TECHNICAL NOTE

Project name Project no.	Resilient NY – Chittenango Creek 1940101594
Client	New York State Office of General Services / NYS Department of
	Environmental Conservation
Technical Note no.	01
Version	1
То	Mr. Tom Snow, PE, NYSDEC
From	Shaun Gannon P.E., D.WRE, P.H., CFM, PMP
Copy to	Mr. Eric Baurle, NYSOGS
Prepared by	Kadir Goz
Checked by	Deborah Coffin, Thomas Snow (NYSDEC)
Approved by	Shaun B. Gannon P.E.

1 Addenda to Resilient NY Flood Mitigation Initiative, Chittenango Creek Final Report dated June 7, 2022

Figure 1. Location map of dam and feeder canal to the Erie Canal along Chittenango Creek.

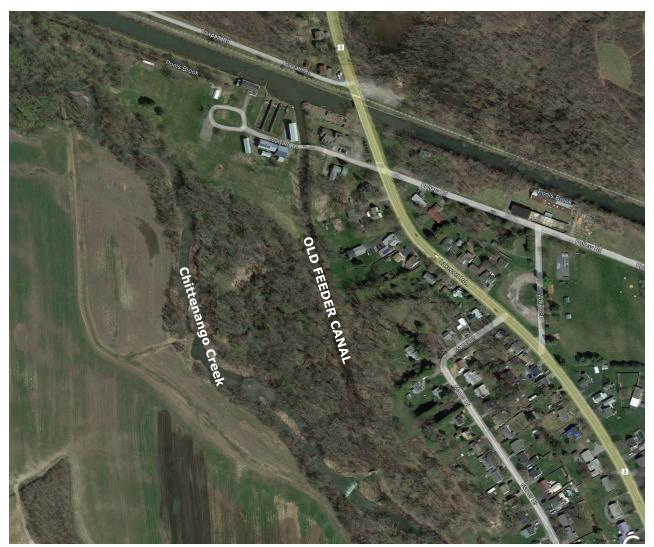
Alternative # 3-9: Reconnection of the Feeder Canal to the Erie Canal

When the historic Erie Canal was constructed, a dam was placed across Chittenango Creek allowing for flow to be diverted into an adjacent feeder canal, suppling the Erie Canal (Figure 1). Currently this diversion is not in operation. Further investigation, including detailed hydraulic modeling, should be performed to assess potential impacts on upstream flooding.
